ADDENDUM NO. 03

Date: 09.19.2025

Project: Sheridan HS and MS School Renovation Project

The Hagerman, Inc portion of this Addendum consists of the following information:

AD201B PROJECT NUMBER 2024037

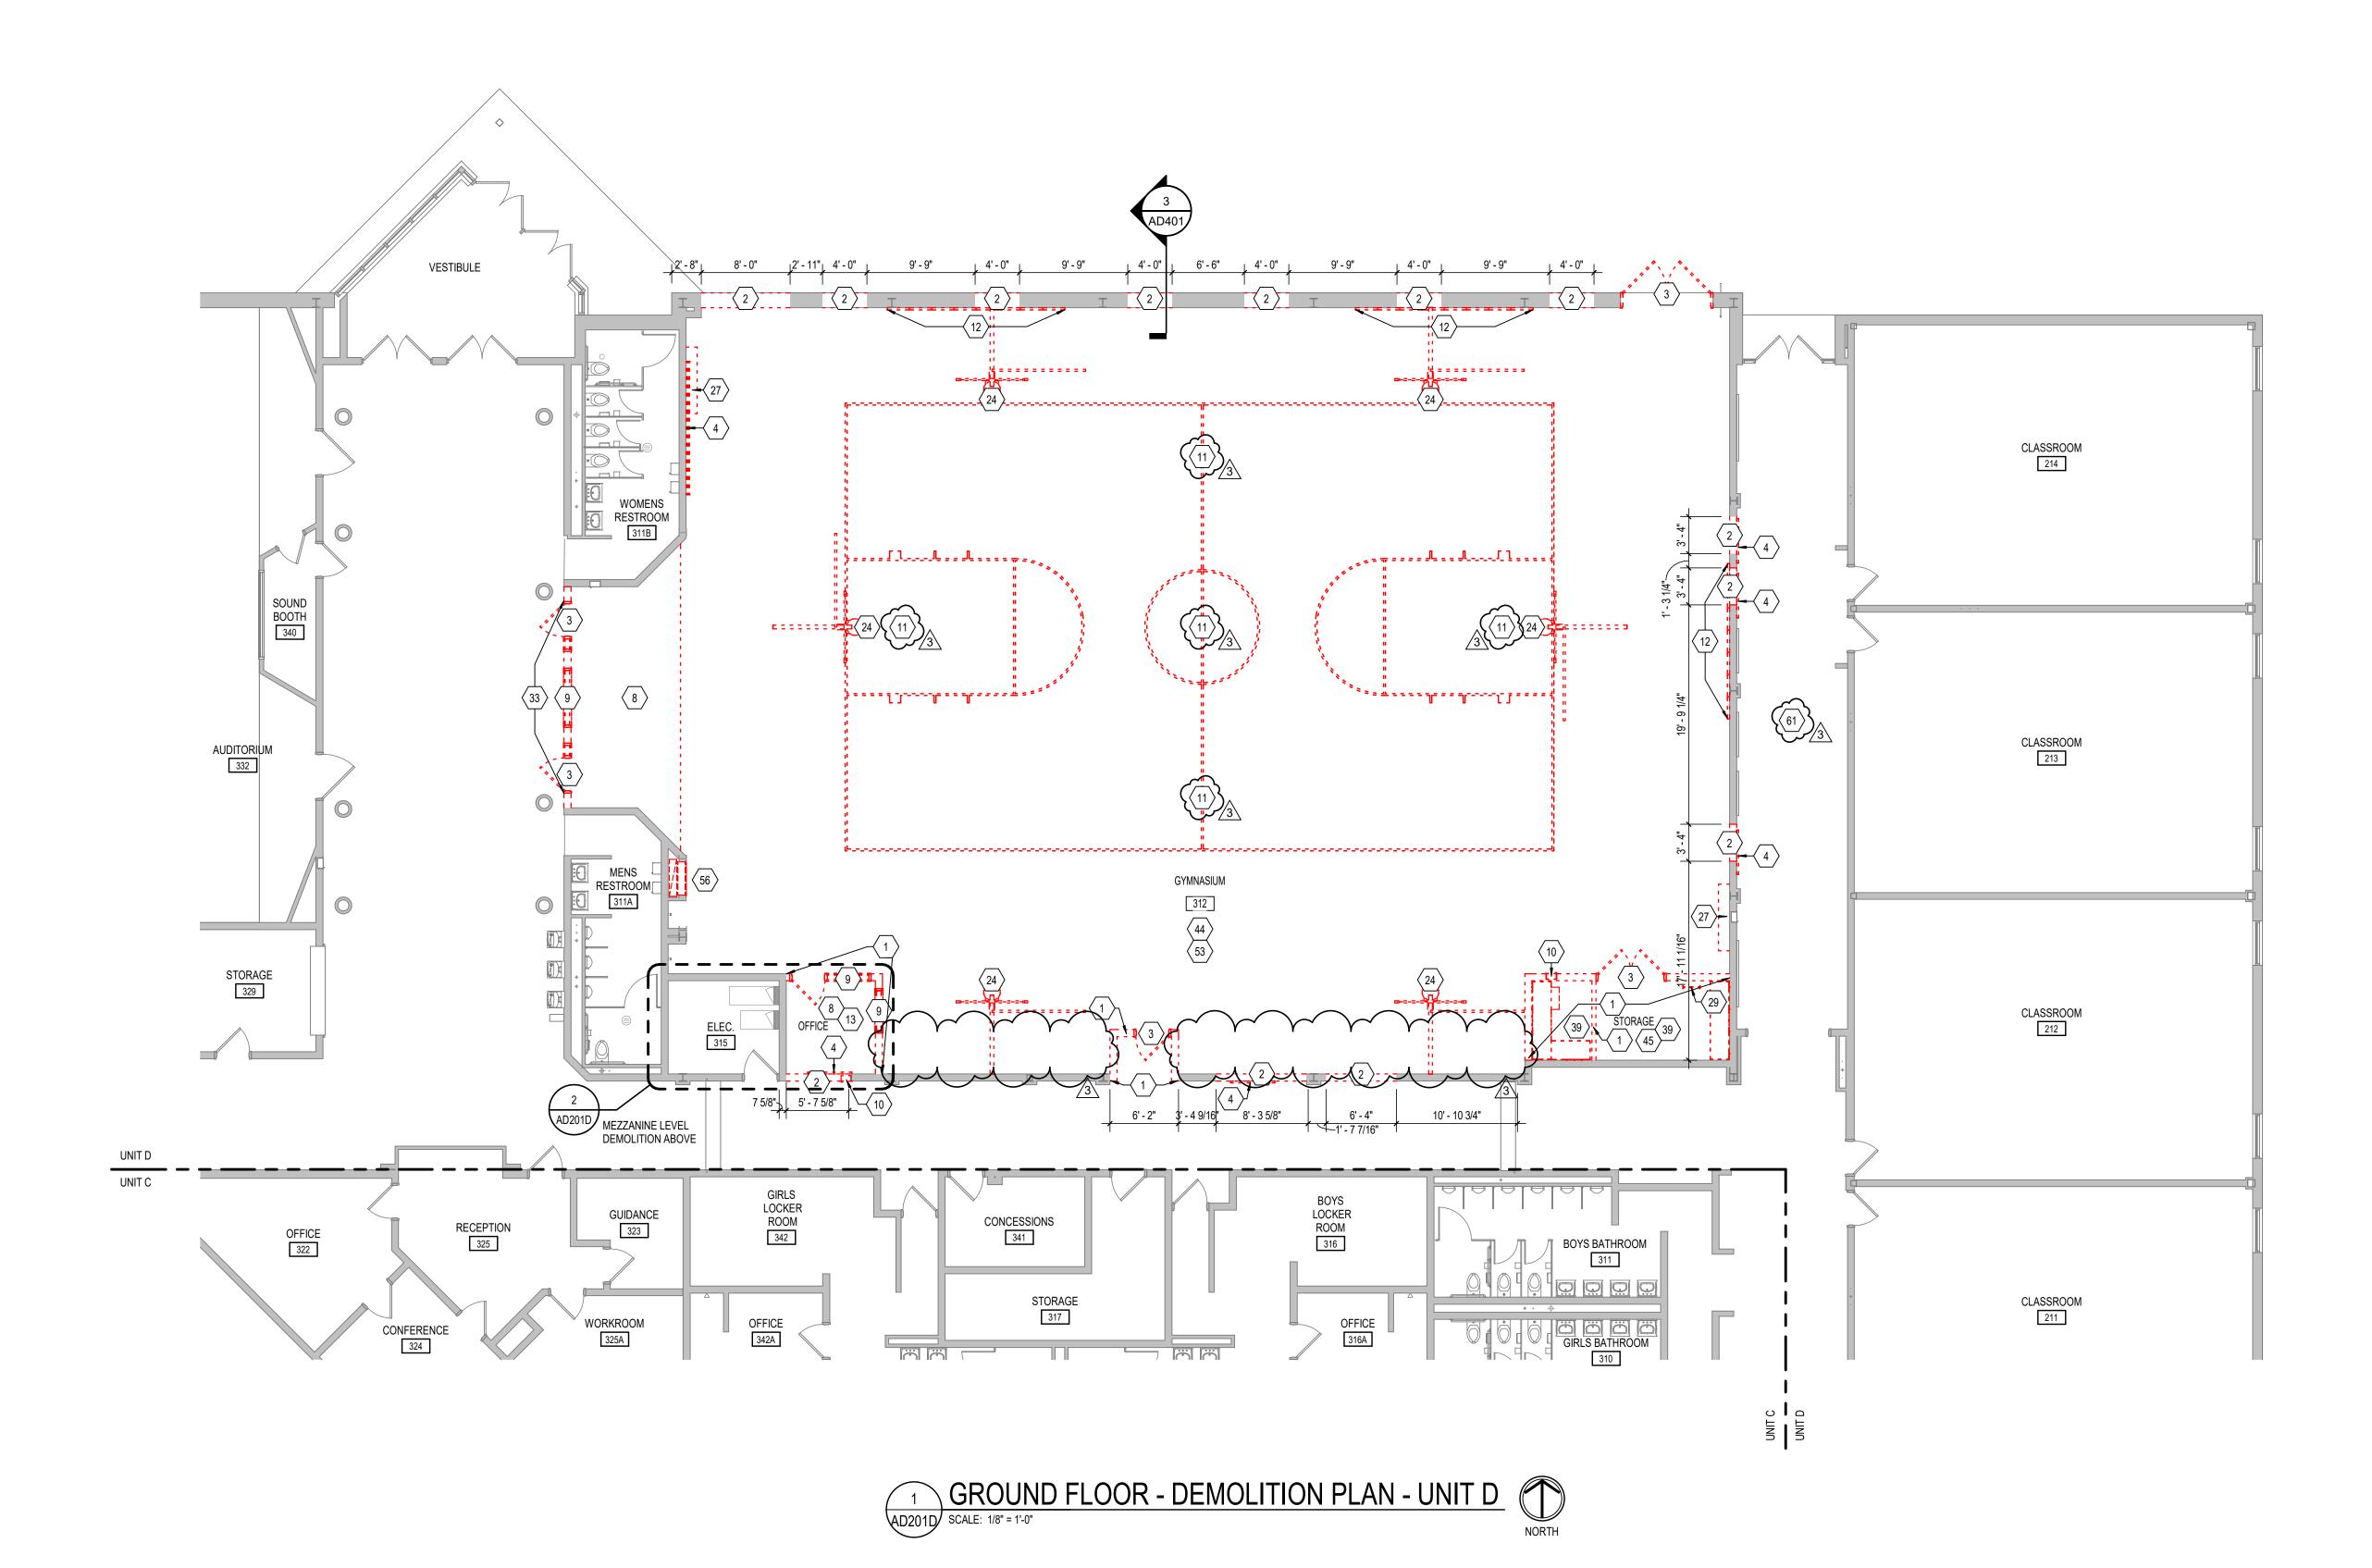
- 3.3 <u>AD201A GROUND FLOOR DEMOLITION PLAN UNIT A</u>
 - A. Revise wall demo dimensions for new opening to Mechanical 300.
- 3.4 <u>AD201B GROUND FLOOR DEMOLITION PLAN UNIT B</u>
 - A. Add note 6 to Storage 124B.
 - B. Add note 60 to Storage 128D, Storage 128E, and Tool Storage 128G.

- C. Add note 61 to corridor.
- D. Add note 60 and note 61 to Demolition Notes.

AD201D

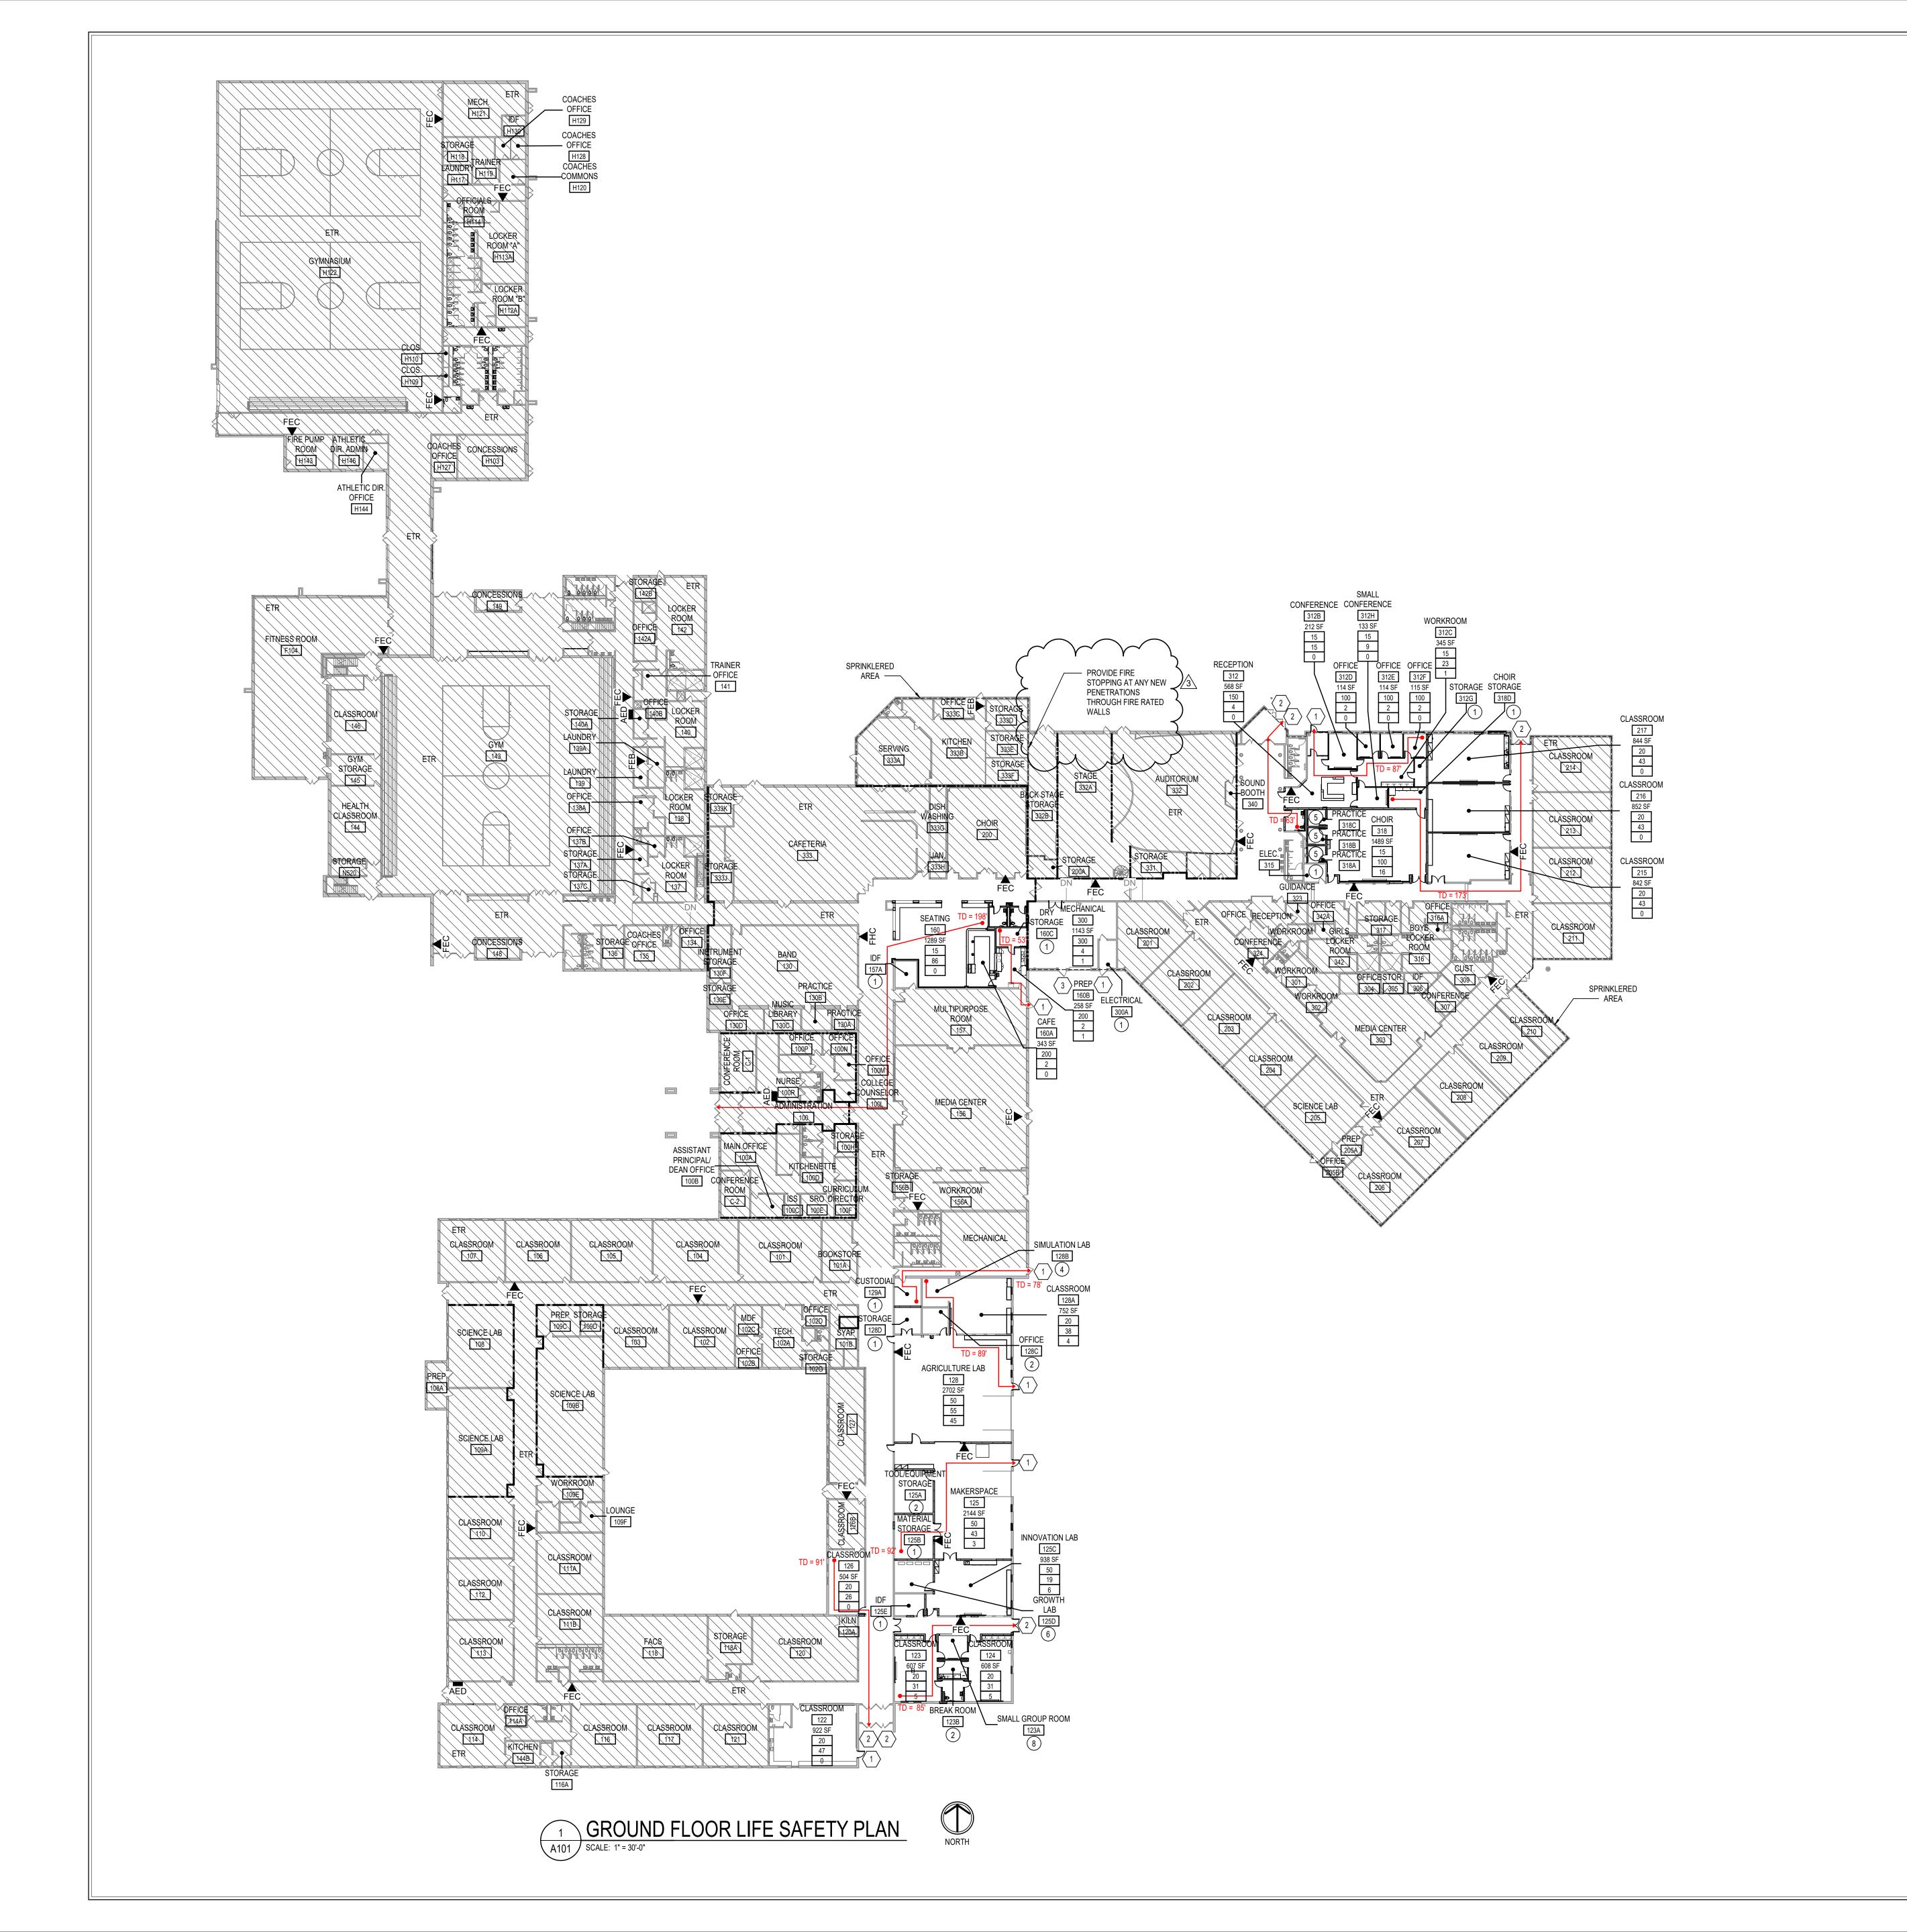
3.5 AD201D - GROUND FLOOR DEMOLITION PLAN - UNIT D

- A. Add note 61 to corridor.
- B. Add note 61 to Demolition Notes.
- C. Revise Demolition Note to read "EXISTING MECHANICAL GRILLE TO BE REMOVED. INFILL OPENING IN WALL."
- D. Remove bleacher demo scope as shown.
- E. Add Demolition Note 11 to gymnasium as shown.
- F. Revise Demolition Note to read "REMOVE AND INFILL EXISTING VOLLEYBALL POST SLEEVE FOR INSTALLATION OF FLOOR FINISH."
- G. Revise Demolition Note 53 to read "EXISTING GYM FLOORING AND BASE REMOVAL AND ABATEMENT COMPLETE BY OWNER. PREP FLOOR FOR NEW FINISH.

DRAWING NUMBER A201A

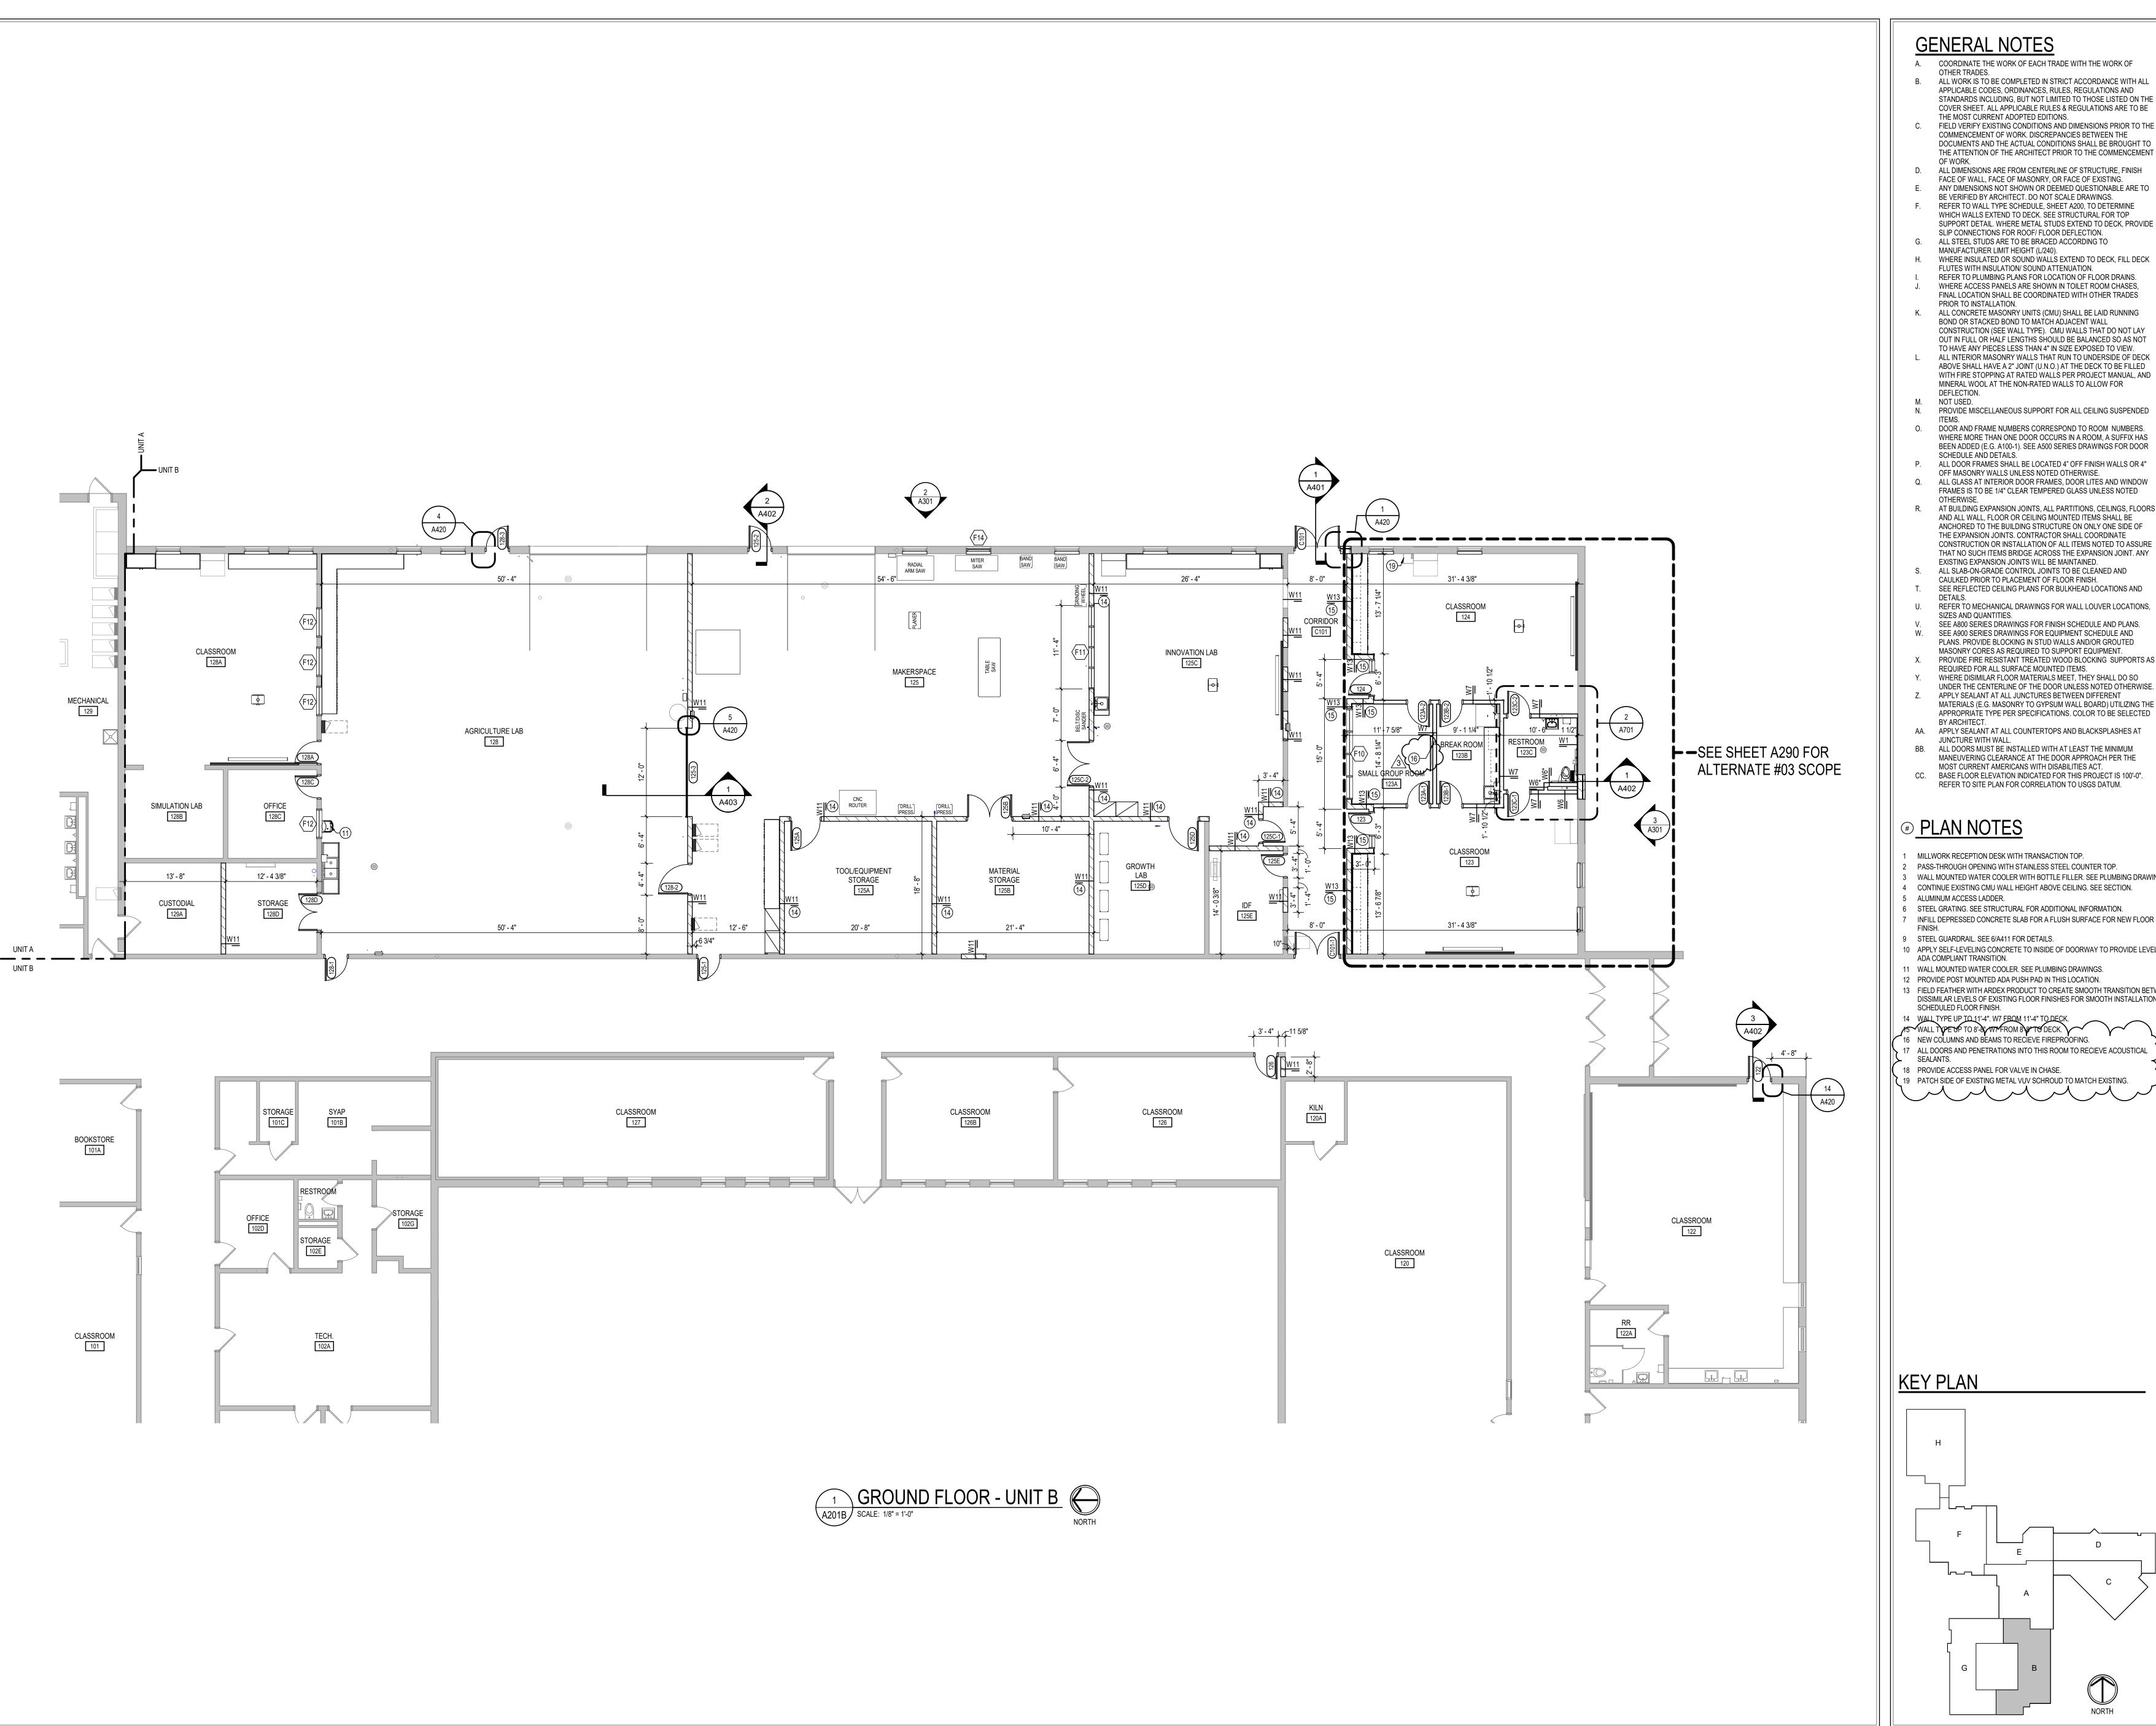
3.7 A201A – GROUND FLOOR PLAN – UNIT A

A. Revise dimension for location of door 300 as shown.
